# 2020/2920/P 32 Hampstead High Street

<b>Delegated Report (Members Briefing)</b>	<b>Analysis sheet</b>		<b>Expiry Date:</b>	10/02/2021
	Attached		<b>Consultation Expiry Date:</b>	17/01/2021
<b>Officer</b>			<b>Application Number(s)</b>	
Josh Lawlor			2020/2920/P	
<b>Application Address</b>			<b>Drawing Numbers</b>	
32 Hampstead High Street London NW3 1JQ			See draft decision notices	
<b>PO 3/4</b>	<b>Area Team Signature</b>	<b>C&amp;UD</b>	<b>Authorised Officer Signature</b>	
<b>Proposal(s)</b>				
Creation of rear roof terrace at 4th floor level for use ancillary to existing Class E office use at 3rd floor level, including erection of rear stair enclosure, installation of balustrades and roof access hatch and other associated alterations.				
<b>Recommendation:</b>	Grant conditional planning permission			
<b>Application Type:</b>	Full Planning Permission			
<b>Conditions or Reasons for Refusal:</b>	Refer to Draft Decision Notices			
<b>Informatives:</b>

Creation of rear roof terrace at 4th floor level for use ancillary to existing Class E office use at 3rd floor level, including erection of rear stair enclosure, installation of balustrades and roof access hatch and other associ

Views of the stair tower at the rear, existing (left) proposed (right)

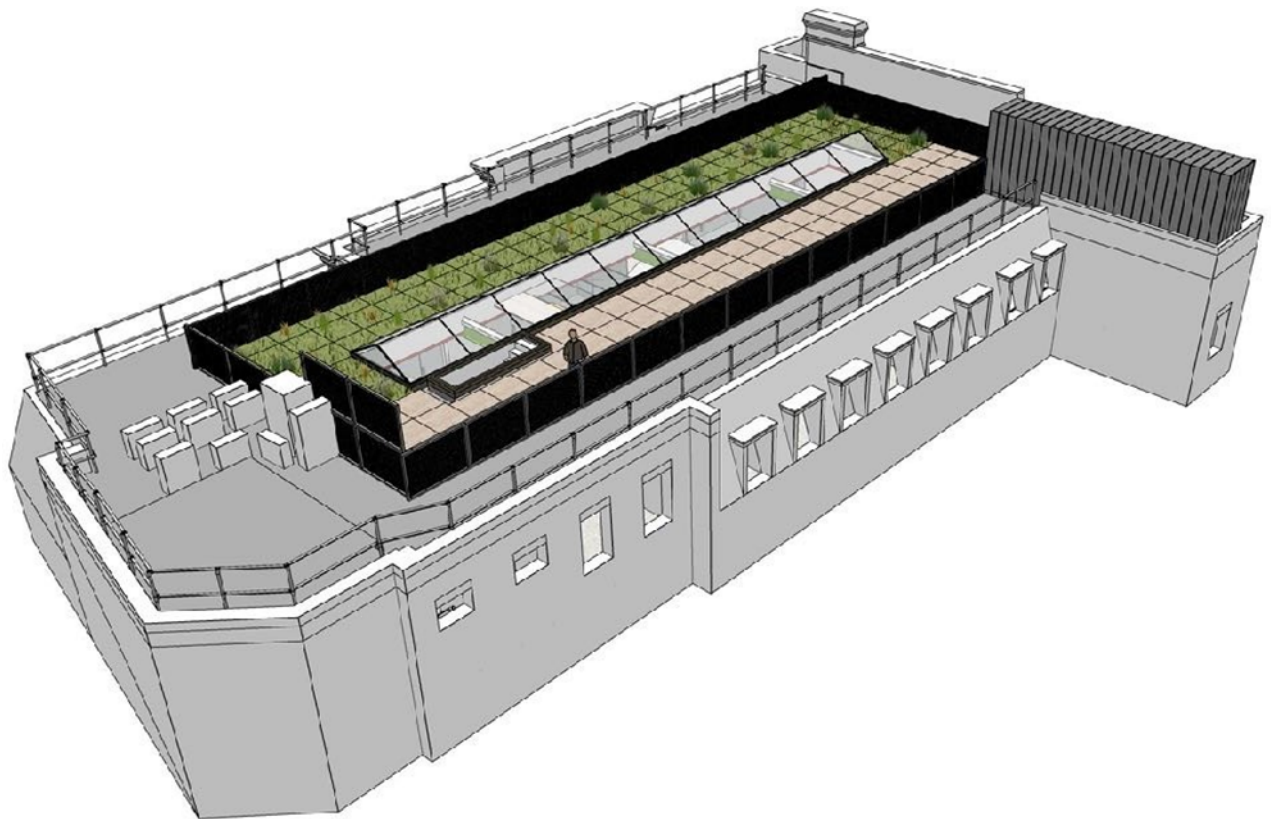
<p><b>The Hampstead Neighbourhood Forum</b></p>	<p>The Forum made the following comment:</p> <p>The new stair housing as means of escape, when the regular access is through a hatch? Is the roof considered a place of safety in an emergency? If not, then a hatch could replace the proposed housing. As it is, the oddity spoils the block's otherwise clean profile.</p> <p>If it is, then lighting needed for H&amp;S - details of such? Should be low-height downward-lighting fittings not offering nuisance to surroundings.</p> <p>The potential for noise nuisance is if many people use the terrace at night-time - office parties come to mind, although not a feature until well into next year if then. The DAS confirms daytime only use, but to be sure. You will</p>

*The new stair housing is considered acceptable in design and heritage terms. The emergency escape strategy is not material to the assessment. Built in lighting is to be kept to a minimum, with only miniature deck-mounted, low-energy, side-emitting light fittings to assist with way finding during darker conditions. These will be within the line of the proposed balustrade and therefore not visible from outside the terrace.*

- 2.1. The stair enclosure and balustrades were originally proposed to be timber-clad and timber slats, but they've taken our advice and amended them to a lead coloured metal cladding for the stair enclosure, and perforated metal mesh screens for the balustrades and the 1.8m high privacy screen to the east of the proposed terrace. The proposal to use metal rather than timber fits far better with the character of the building

Schematic view of the roof showing the new accessible area, green roof area, and inner balustrade. The Raised sight screen is on the left, the stairhead on the right.

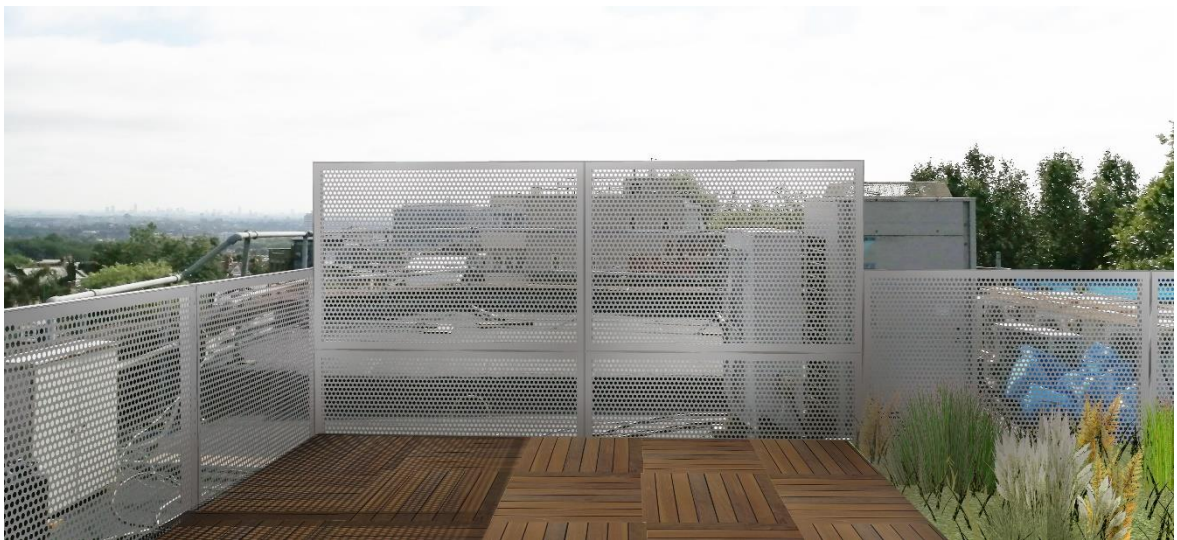
<b>Consultations</b>				
<b>Summary of consultation:</b>	Site notices were displayed near to the site on the 12/08/202 (expiry 05/09/2020)  The application was also publicised in the local press from 06/08/2020 (expiry 30/08/2020)			
<b>Adjoining Occupiers:</b>	No. of responses	1	No. of objections	1
<b>Summary of consultation responses:</b>	An objection was received from unknown 1 address:  I have no objection in principle to a roof terrace, but am concerned that the proposed terrace would have a direct view into my bathroom and into my bedroom beyond that.  <i>Officer response:</i>

Attention to the roof finish and thermal improvement is welcome - can the green roof be of the deeper type to try for bio-diversity?

<p><i>The addition of the raised sight screen at the southeastern end of the accessible terrace area was made in response to this concern, and precludes any such overlooking.</i></p>
<p><b>Hampstead CAAC</b></p>	<p>HCAAC states that it objects initially to the proposal: It is clearly aimed at allowing a crowd of people onto the roof where previous access will have been for maintenance only. We must see the effect on the surrounding properties as to potential noise nuisance.</p> <p>No description of that detail in the application heading, no statement is offered - how validated without a DAS? HCAAC always asks such things.</p> <p>Please have that submitted for further consideration, let us see what exactly is involved, people numbers etc. We would expect it will confirm daytime only use, but to be sure. The area will have to be lit against the possibility of night-time access, so details of that also needed.</p> <p>Redundant AC units are to be removed to accommodate the new stair housing - a good move hopefully not to be substituted with new units.</p> <p>Attention to the roof finish and thermal improvement also welcome - can the green roof be of the deeper type to try for bio-diversity?</p> <p>The new stair housings are not welcome if distorting the otherwise clean roof profile, but use for persons in numbers probably necessitates. Maintenance access still required to the roof perimeters - how is that to be safeguarded - must be a gate somewhere?</p> <p><i>Officer Response:</i></p> <p><i>The applicant has provided a Design and Access Statement. Built in lighting is to be kept to a minimum with only deck-mounted, low-energy, side-emitting light fittings to assist with way finding during darker conditions. These will be within the line of the proposed balustrade and therefore not visible from outside the terrace.</i></p> <p><i>Please see the Design/Heritage, Amenity sections of this report for further information.</i></p>

- 4.4. The part of the roof to the south of the large rooflight is to be laid to green roof using the Grufetile modular green roof system with Sedum and Wildflower mix. This area will not be accessible except for maintenance, but will make a positive contribution to biodiversity and water-runoff rates. The applicant has provided details of the green roof to show that it would have appropriate substrate depth to support the variety of wildflowers and sedum proposed. A maintenance plan has been provided which demonstrates that it would be sustainable.
